NEXEDGE®

Release Notes

Information for June 2023 update

Document No. RN-23-0001

1.1. Telephone Call (via the repeater)

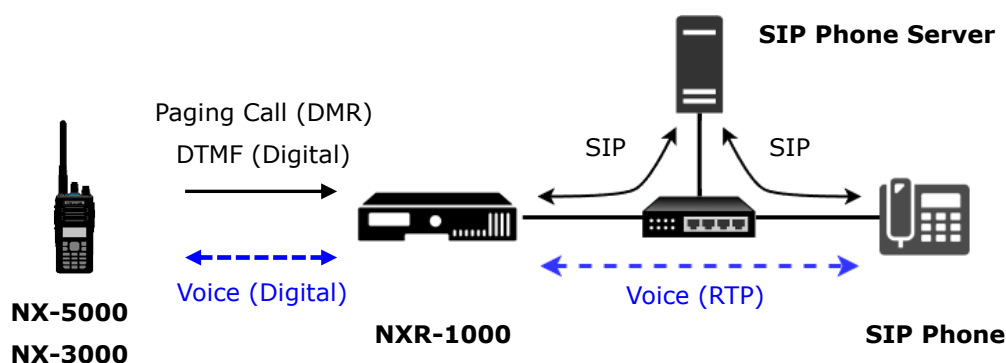
The Subscriber Unit (SU) can send a connection request to a SIP Phone to a Repeater connected to a SIP Phone Server. DTMF codes or Paging Call is sent via digital communication within a session to establish a connection with a PABX/PSTN SIP Phone. Once the connection is established, the SU and the SIP Phone can communicate via the Repeater. It is also possible that the SIP Phone initiates a call to the SU.
